ADDENDUM NO. 1

DATE: December 4, 2018

PROJECT: ITB 19163

MUNICIPAL STADIUM PRESS BOX WINDOW REPLACEMENT

A-103

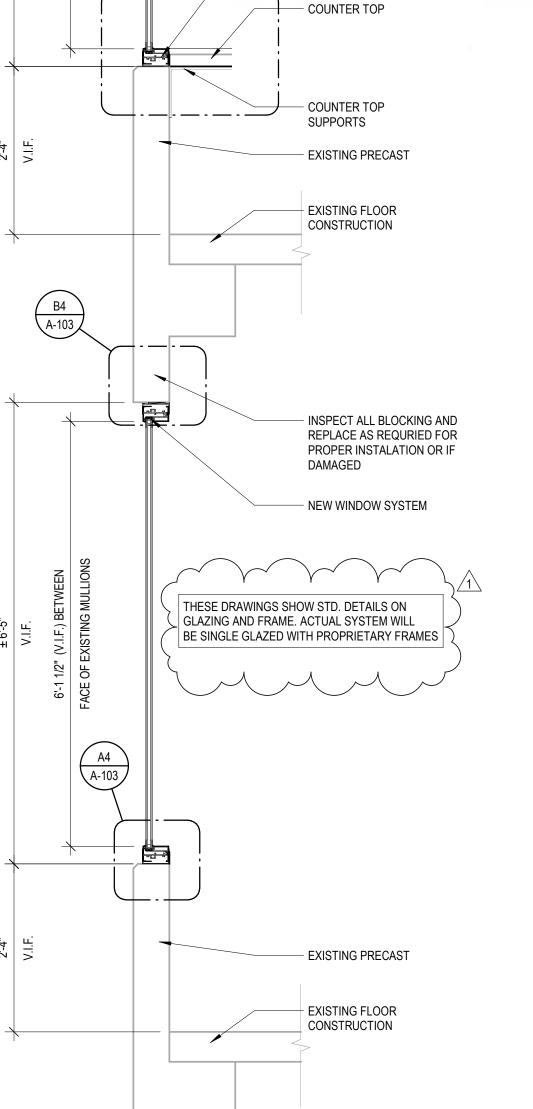
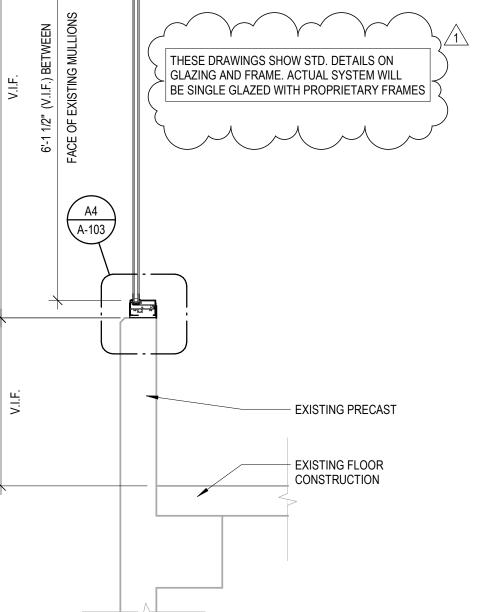
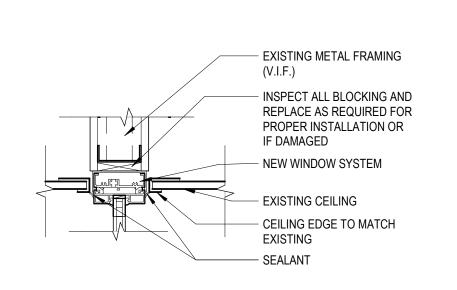
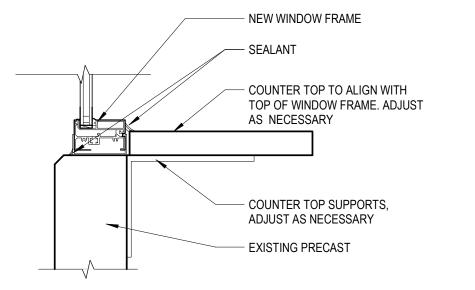
Q4: Details on A-103 imply insulated glass but the specified system (Faour's Slimpact SSG Glasswall) only has FL Product Approvals for non-insulated glass. Is non-insulated glass acceptable for this butt-glass application?

- NOTE: If a system exists that allows the use of insulated glass in a butt-glass configuration, the insulating bands of adjacent glass panels would be visible, creating a 1 1/2" to 1 1/2" wide black stripe at every butt-joint. This band would negate the clean lines intended by the spec.
- A4: The installed system shall be Faour's Slimpact SSG which is only available as a single pane, non-insulated system. Pending local approval, the use of non-insulated glass would be acceptable. Please reference revised sheet A-901 (attached).
- Spec Section 085113-2.1.B calls for a Thermally Broken Frame, but the Q5: specified manufacturer doesn't have a thermally broken frame approved. Is a Non-thermally broken frame acceptable?

- INTERIOR WINDOW FRAMES

TO MATCH AND ALIGN WITH

NEW EXTERIOR WINDOW

SYSTEM (BEYOND)
